Access Compliance Report Public Rights-of-Way (Curb Ramps)

Intersection ID: N/A Main Street: COSTIGAN LN **Cross Street: DURANT BV** Location: **Overall Compliance: No** ADA ID: AB0BADD962C3 Ramp Type: PerpDiag Initial Pass/Fail: Fail Severity Score: 21.25

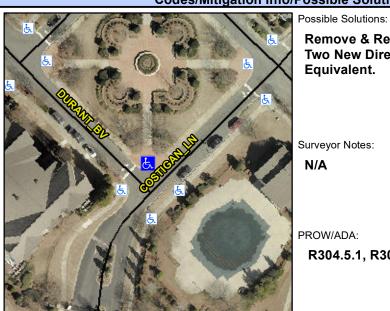
R304.5.1, R304.2.2

Compliance Description			Data	Compliance Description			Data
			Data				Data
N/A	Ram	Length (in)	81.0	No	Ramp	o Slope (%)	9.1
No	No Ramp Width (in)		46.0	Yes	Ramp	XSlope (%)	0.6
N/A	Flare	Type LT	N/A	N/A	Flare	Type RT	N/A
N/A	Flare	Slope LT (%)	N/A	N/A	Flare	Slope RT (%)	N/A
N/A	Flare	Traversable LT?	N/A	N/A	Flare	Traversable RT?	N/A
N/A	Land	ing Length (in)	N/A	N/A	DWS	Provided?	N/A
N/A	Land	ing Width (in)	N/A	N/A	DWS	Contrast?	N/A
N/A	Land	ing Slope (%)	N/A	N/A	DWS	Length (in)	N/A
N/A	Land	ing X Slope (%)	N/A	N/A	DWS	Full Width?	N/A
N/A	Land	ing Curb? (Y/N)	N/A	N/A	DWS	Offset (in)	N/A
N/A	Share	ed Landing?	N/A				
N/A	Gutte	er Ponding?	N/A	N/A	Gutte	er Slope (%)	N/A
N/A	Gutte	er Lip Ht (in)	N/A	N/A	Gutte	er X Slope (%)	N/A
N/A	Paint	ed X Walk1?	No	N/A	Paint	ed X Walk2?	No
	X Wa	lk 1 Direction	To SW		X Wa	lk 2 Direction	To SE
N/A	X Wa	ılk 1 Width (in)	N/A	N/A	X Wa	lk 2 Width (in)	N/A
	X Wa	ılk 1 Slope (%)	2.1		X Wa	lk 2 Slope (%)	0.9

Remove & Replace Curb Ramp With Two New Directional Ramps or Equivalent.
